Staff Report & Recommendation

Historic Preservation Board

SUBJECT: HPB0716-0046, **915, 947 and 955 Washington Avenue – Moxy Hotel**.

The applicant has submitted plans entitled "Moxy South Beach" as prepared by Kobi Karp Architecture, Interior Design, Planning, dated September 1, 2016.

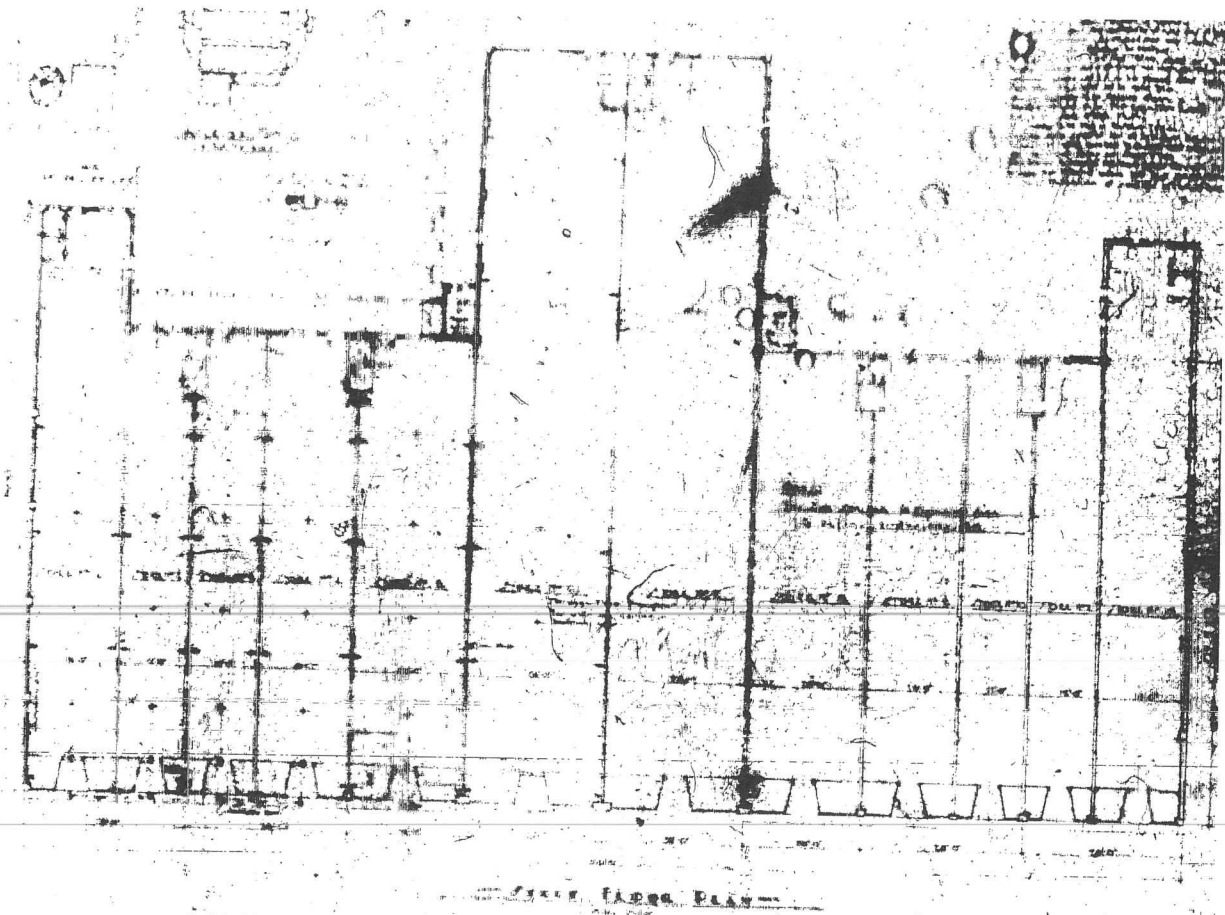
Staff is pleased that the applicant is proposing to restore the upper facades of all three structures on the site however, staff has some concerns with regard to the modifications proposed for the storefront systems, bay configurations and parapet walls.

915 Washington Avenue - West Elevation Building Permit No. 8343

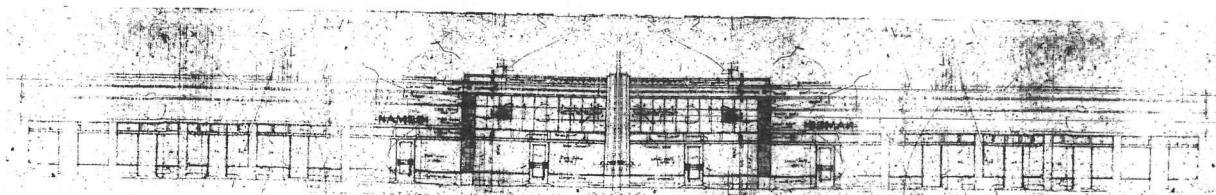
The symmetrical plan for 915 Washington Avenue is characterized by two central bays of equal width flanked by five bays of varying widths to either side. The applicant is proposing reconfigure the façade so that it is no longer symmetrical. The proposed façade consists of three bays to the south and four bays to the north, inconsistent with the original design of the 'Contributing'

building. Consequently, staff would recommend the 5-2-5 façade configuration be retained in a manner consistent with the original building permit plans shown below.

Additionally, within the southern three bays of the north wing, the applicant is proposing to introduce an open to the sky dining area. As a part of this open air concept, angled breeze block walls and knee wall height planters are proposed to be introduced in place of the storefront windows, loosely recalling the existing entry condition. Further, the breezeblock pattern is inspired by the decorative upper façade relief feature.

Within the central two bays, the applicant is proposing to setback the storefront windows approximately 3'-0" eastward of the building façade. This will result in at least one 'floating' rectangular column where the existing fluted pilasters are located. Staff believes this condition is highly inconsistent with the original design and would therefore recommend that the storefront glazing, with the exception of the entry doors, not be recessed. Additionally, within this portion of the building, the applicant is proposing to install what appears to be a metal clad awning or concrete eyebrow. Regardless of the proposed material, staff believes that this continuous horizontal element which spans both bays interrupts the vertical emphasis of the center portion of the building. Consequently, staff recommends the elimination of this element.

With regard to the proposed storefront window design, staff would note that it appears from the renderings provided, that the applicant is proposing a semi mirrored glass, dark colored window frames and frameless glass doors. In order to be more consistent with the original design of the building, staff would recommend clear glass windows with the minimum tint to comply with energy codes, clear anodized aluminum, powder coated grey or silver frames and doors with a frame and kick plate. Additionally, after examining the original permit plans, staff believes that all of storefronts contained transom lites, and would recommend the reintroduction of transoms within the storefront windows consistent with the original design shown above.

- b. The 5-2-5 bay configuration of the building at 915 Washington Avenue shall be maintained, in a manner to be reviewed and approved by staff consistent with the Certificate of Appropriateness Criteria and/or the directions from the Board.

- c. The recessed storefront windows of the center two bays of the 915 Washington Avenue building shall not be approved. All storefront glazing, with the exception of the two entry doors, shall be aligned with the exterior face of the west elevation, in a manner to be reviewed and approved by staff consistent with the Certificate of Appropriateness Criteria and/or the directions from the Board. This shall not prohibit entry doors from being recessed.

- d. Transom windows shall be introduced within the storefront windows on the 915 Washington Avenue building consistent with available historical documentation, in a manner to be reviewed and approved by staff consistent with the Certificate of Appropriateness Criteria and/or the directions from the Board.

- e. The scored stucco grid pattern located at the center two bays of the 915 Washington Avenue building shall be reintroduced consistent with available historical documentation, in a manner to be reviewed and approved by staff consistent with the Certificate of Appropriateness Criteria and/or the directions from the Board.

- f. The original parapet walls shall not be increased in height.
 - g. The awning/eyebrow structure located at the center two bays of the 915 Washington Avenue building shall not be permitted.
